ADDENDUM No. 1

RFP No. 23-04

Broadway Street Water Main Replacement and Resurfacing Project

Z:\2021\211210\CAD\CD\211210_details.dwg - Plot Date: 1/13/2023 2:24:17 PM

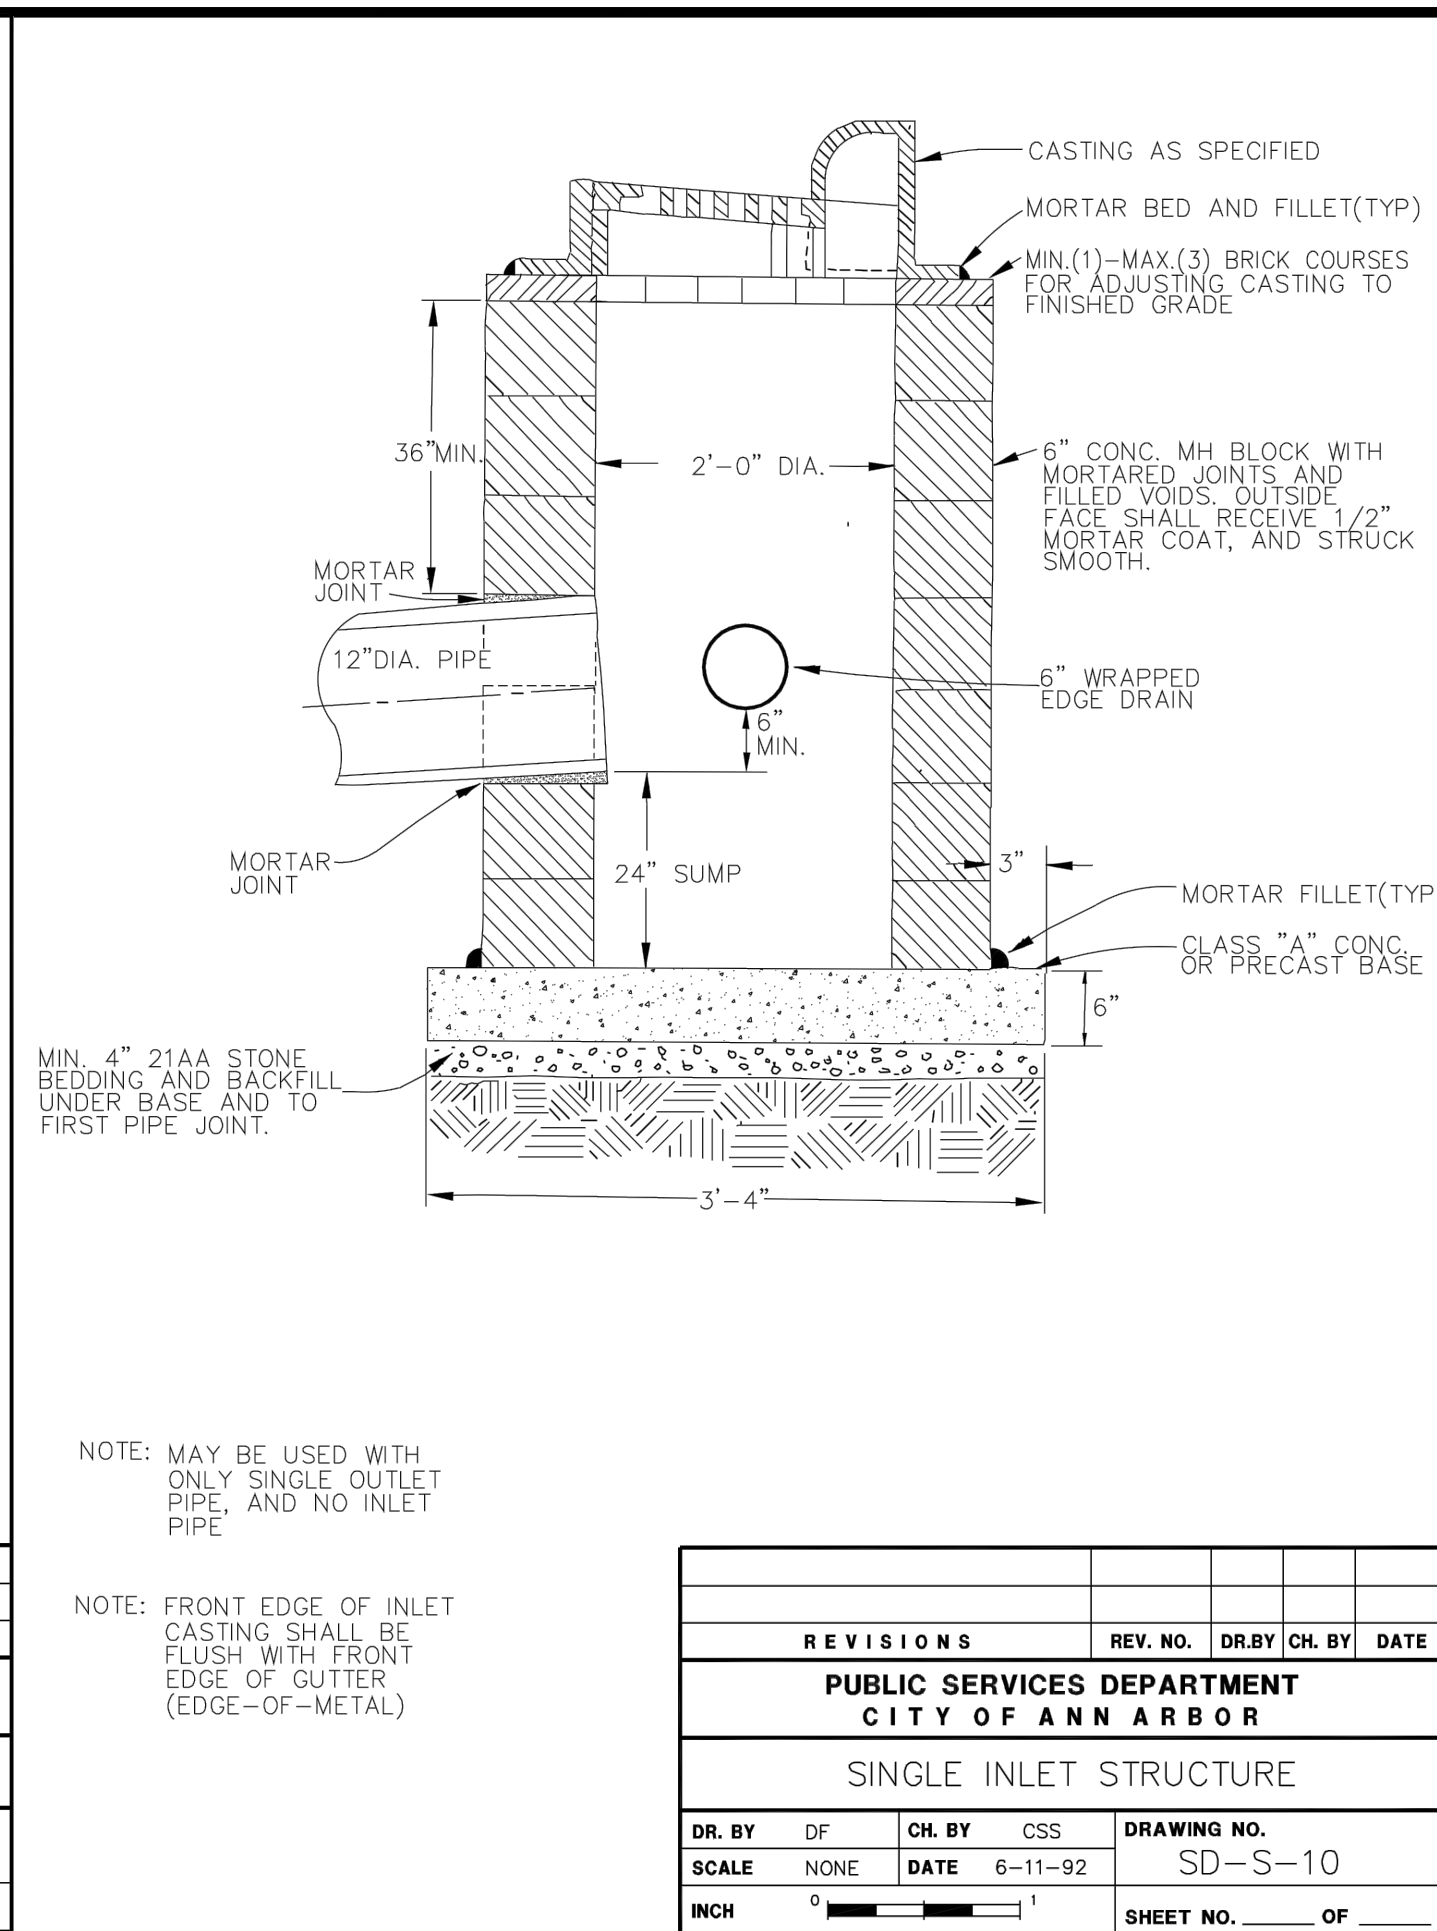
Section/Page(s)	Change
Replace Plan Sheets 11-12	Revised Standard details.
Replace Plan Sheets 15-18	Revised sheets to include catch basins and storm leads Revised sheets to include update location of exiting gas main.
Replace Plan Sheets 31-35, 37, 39-41	Revised sheets to include catch basins and storm leads Revised sheets to include update location of exiting gas main. Revised sheets to include structure and sewer table
